19 October 2021

Kurri Kurri Lateral Pipeline Project update

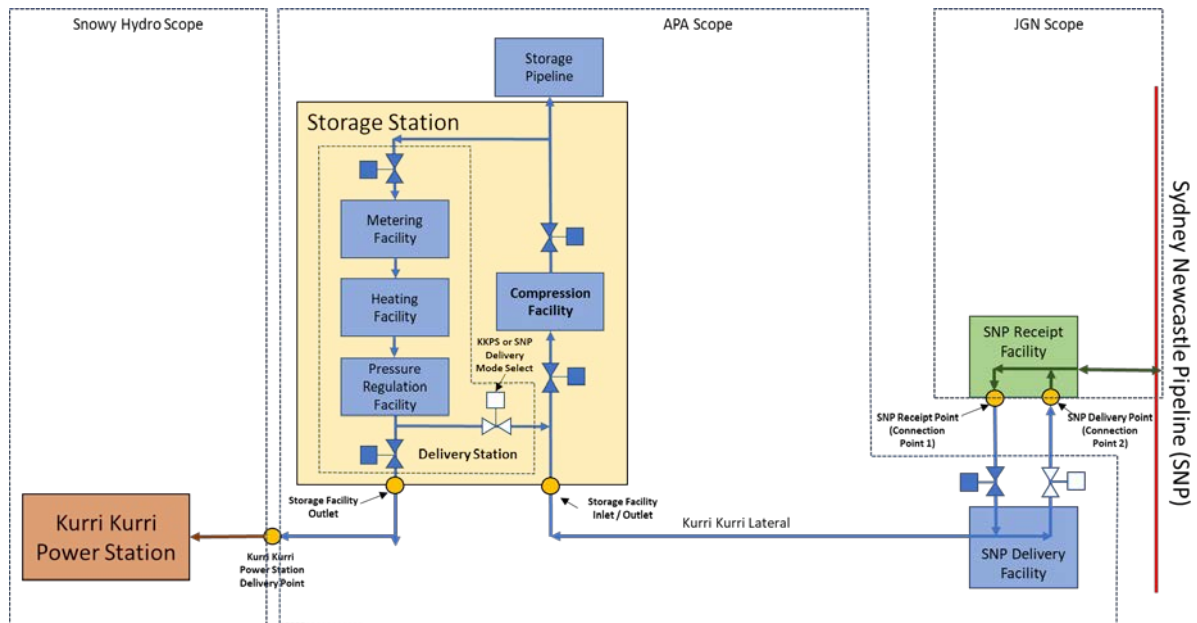
Design changes to enable this functionality entail connection of the delivery station, which controls the flow of gas from the storage pipeline to the HPP, to the transmission pipeline. Flow direction would be controlled by on/off switching. There are no material changes to the construction footprint or operational impacts of the delivery station as a result of this capability.

In addition, a reconfiguration of the offtake facility (which controls gas flow from the SNP into the transmission pipeline) is required to enable bi-directional flow. Rather than a single facility, two separate but co-located facilities referred to as the 'SNP receipt facility' (to be operated by Jemena) and the 'SNP delivery facility' (to be operated by APA) are now proposed.

The co-located facilities would encompass an area of approximately 0.5 to 1ha proximal to the SNP, and within the study corridor presented in the Scoping Report.

Jemena, as the operator of the SNP, would be responsible for the design, planning approvals, construction and operation of the SNP receipt facility, as well as a short section of pipeline between the SNP receipt facility and the SNP. Based on the currently proposed location, the length of the connecting pipeline would be approximately 600 m.

A schematic of this arrangement is provided below.
